Response to Sizewell C DCO Issue-specific hearing 6 (ISH6) Coastal geomorphology meeting on the 14th July 2021.

Author: Nick Scarr, Interested Party number 20025524

This document is a response to the issue specific geomorphology hearing (ISH6). This paper relates primarily to the agenda item referring to the Sizewell-Dunwich banks and their relevance to the flood risk and shoreline change assessments submitted by the Applicant.

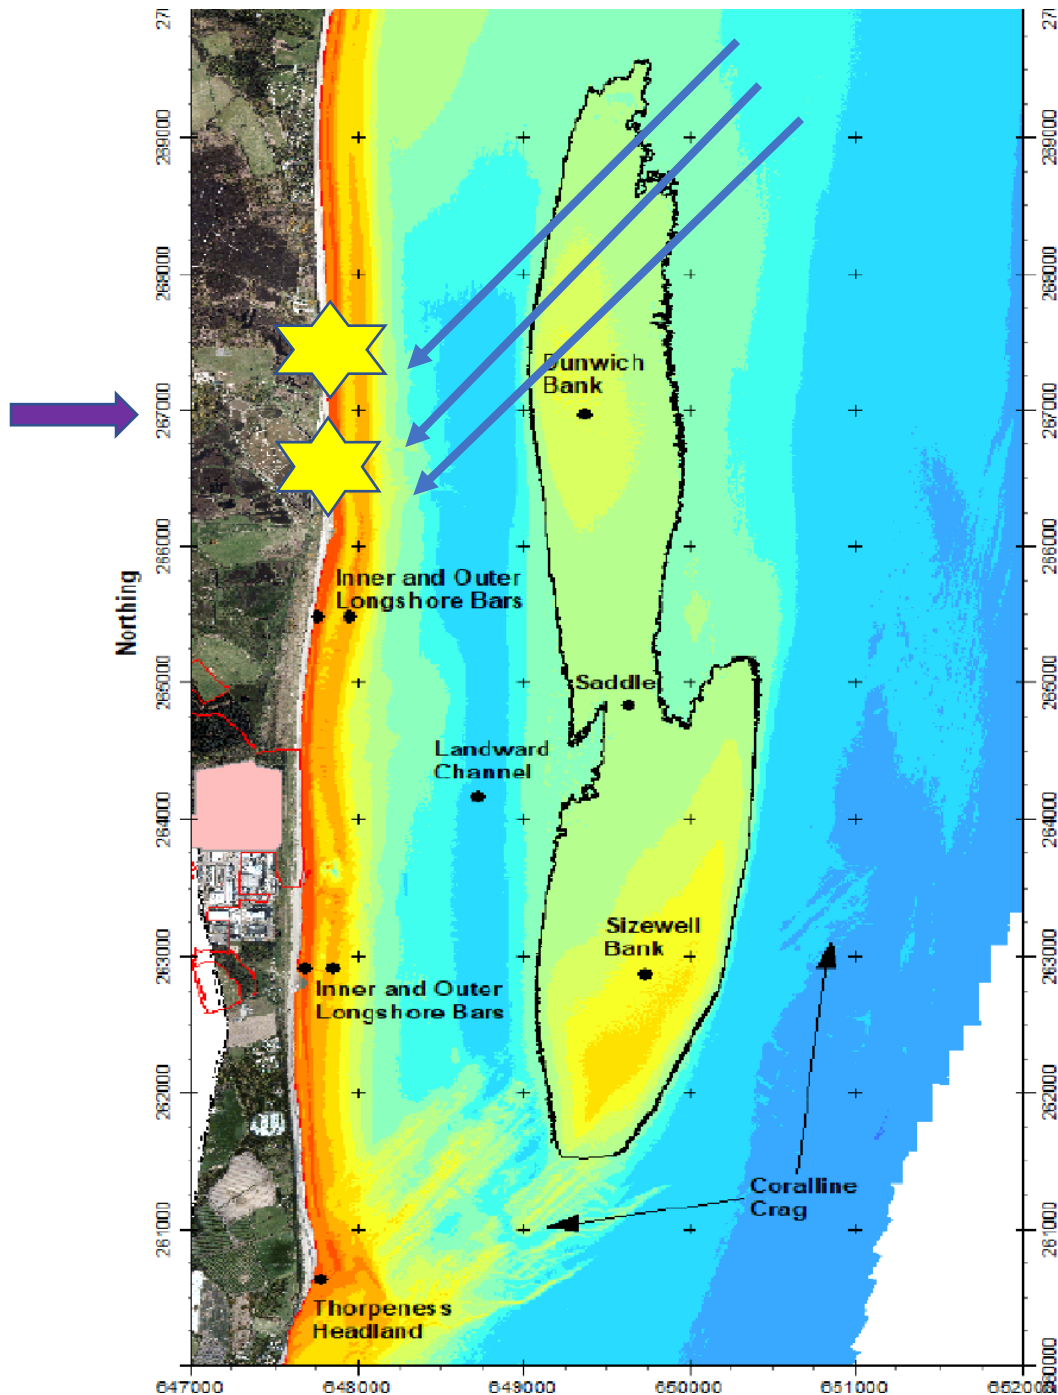
The Dunwich bank is simply no longer important, the following is EDF's response to the MMO, 'First Written Questions' during the DCO:

- 3.1 "Wave breaking is determined by the ratio of water depth (h) to wave height (H_b), where $H_b / h = 0.78$. Typical H_b for waves breaking over feature crests are:

- Sizewell Bank ($h = 5-7m$), $H_b = 3.9-4.5m$,
 - Dunwich Bank ($h = 7-8m$), $H_b = 5.5-6.2m$ "
- (My comment 1: These data do not appear to be consistent with accepted academic and empirical research- see 'Tucker Carr' referenced below). EDF continues: "This suggests that wave breaking on the Dunwich bank is very rare because the maximum significant wave height recorded in the last 13 years, 2.5 months is 4.72 m (i.e. the more mobile section of the bank does not significantly affect inshore wave climate). Thus, despite recent lowering and reduction in the extent of Dunwich Bank, historical erosion of Dunwich Cliffs is not recurring" (My comment 2: see below) 9.11 Responses to the ExA's First Written Questions (ExQ1) Volume 1 - SZC Co. Responses. REP2-100, Page 40 of 253 (overall PDF page no: 539)

This statement above does not appear to be consistent with academic research or EDF's own research:

My comment 1. The work of **Tucker and Carr** using Waverider buoys installed in the 1970s (and later work by BEEMS, and EDF, including modelling) shows that any incident wave approaching the Sizewell-Dunwich banks from offshore, if higher than a critical value, is forced to break on the offshore banks thereby reducing its height to that value before it hits the Sizewell coastline. This critical value of wave height is **2.12m to 2.52m** depending on tidal depth. This feature of the Sizewell-Dunwich bank complex is of primary importance to the inshore wave climate and protection of the Sizewell foreshore. This is acknowledged in the [DCO: Coastal Geomorphology and Hydrodynamics, Appendix 20A. op cit., Page 27](#). Tucker and Carr's work is also acknowledged in [BEEMS TR319, page 27](#).

My comment 2. **Any and all parts of the Dunwich bank are potentially mobile – it has no 'hard geology'**. Dunwich bank does not control erosion of Dunwich cliffs – they are too far to the North. Dunwich bank controls erosion of the Sizewell/ Minsmere foreshore from North Easterly/Easterly gales. This is explained in the map of the Sizewell Dunwich bank below:
